NOTICE OF PLANNING COMMISISON ACTION

Project Name: Quinn's Water Treatment Plant MPD
Project Description: Master Planned Development for Water Treatment Plant
Date of Action: September 9, 2009

Subject: Quinn's Water Treatment facility
Author: Kirsten A. Whetstone, AICP KAW
Date: September 9, 2009
Type of Item: Administrative – Master Planned Development

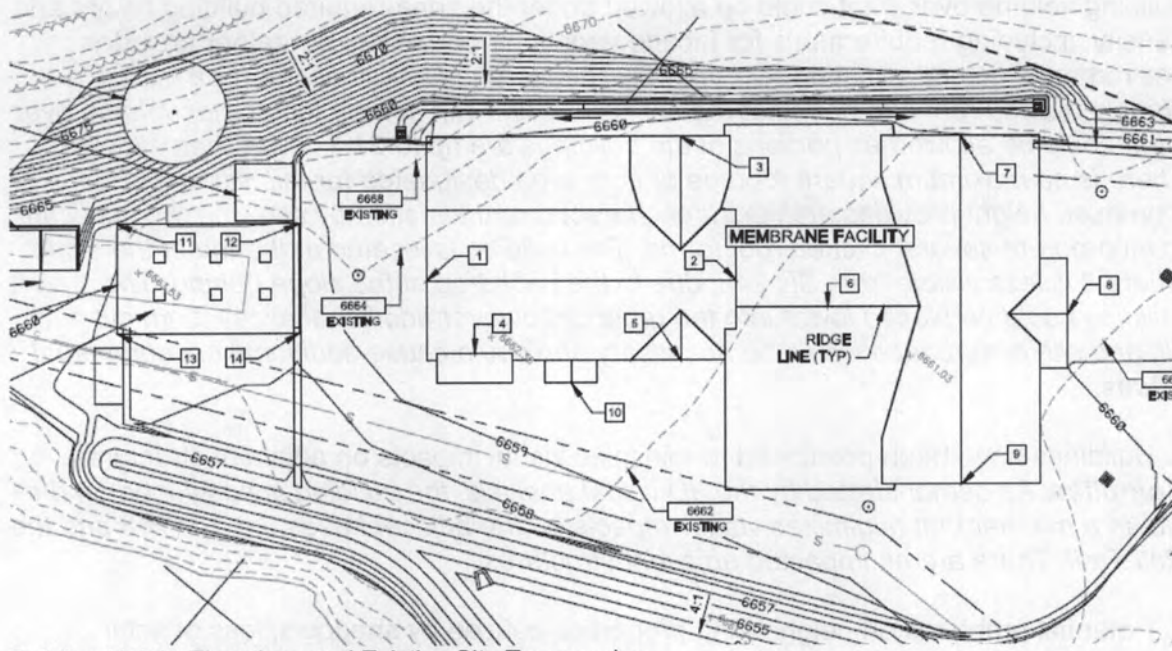
Complies. Additional building height is requested due to the dimensions of interior mechanical equipment, as well as to utilize steeper pitched roof elements for their architectural character and to minimize the amount of excavation and site work

required. Allowed height in the ROS zone is 28' plus 5' for a pitched roof.

At the tallest point the building is 44.4' above existing grade. This occurs at the eastern most north/south running ridge. Closest to the toe of the slope this ridge is 43' above existing grade. The applicant is requested up to 11.4' of additional building height (over the 33' allowed) at this location. Additional height is also requested for the east/west running ridge that is designed at between 34.5' and 41.2' in height above existing grade (1.5' to 8.2' of additional height is requested).
